Access Compliance Report

Public Rights-of-Way

(Curb Ramps)

Intersection ID: 2499	Main Street: LAGRANDE_DR	Cross Street: HIGHLAND_CREEK_PY	Location: NE
ADA ID: 673B9D044A97	Ramp Type: PerpDiag	Initial Pass/Fail: Fail	Overall Compliance: No
Severity Score: 12.5			
Codes/Mitigation Info/Possible Solution		Field Measurements/Component Compliance

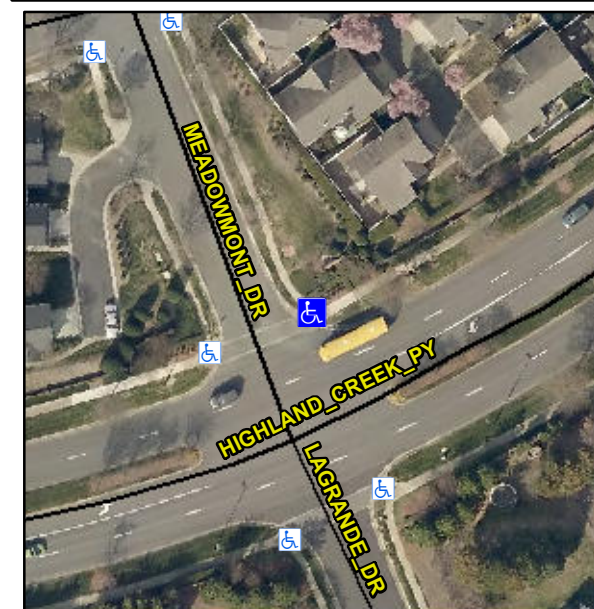
R304.2.2

Compliance	Description	Data	Compliance	Description	Data
N/A	Ramp Length (in)	53.0	No	Ramp Slope (%)	10.1
Yes	Ramp Width (in)	53.0	Yes	Ramp XSlope (%)	1.9
N/A	Flare Type LT	N/A	N/A	Flare Type RT	N/A
N/A	Flare Slope LT (%)	N/A	N/A	Flare Slope RT (%)	N/A
N/A	Flare Traversable LT?	N/A	N/A	Flare Traversable RT?	N/A
N/A	Landing Length (in)	N/A	N/A	DWS Provided?	N/A
N/A	Landing Width (in)	N/A	N/A	DWS Contrast?	N/A
N/A	Landing Slope (%)	N/A	N/A	DWS Length (in)	N/A
N/A	Landing X Slope (%)	N/A	N/A	DWS Full Width?	N/A
N/A	Landing Curb? (Y/N)	N/A	N/A	DWS Offset (in)	N/A
N/A	Shared Landing?	N/A			
N/A	Gutter Ponding?	N/A	N/A	Gutter Slope (%)	N/A
N/A	Gutter Lip Ht (in)	N/A	N/A	Gutter X Slope (%)	N/A
N/A	Painted X Walk1?	Yes	N/A	Painted X Walk2?	No
	X Walk 1 Direction	To W		X Walk 2 Direction	To S
N/A	X Walk 1 Width (in)	81.0	N/A	X Walk 2 Width (in)	N/A
	X Walk 1 Slope (%)	1.2		X Walk 2 Slope (%)	1.8
	X Walk 1 X Slope (%)	0.7		X Walk 2 X Slope (%)	0.6

Remove & Replace Curb Ramp With Two New Directional Ramps or Equivalent.
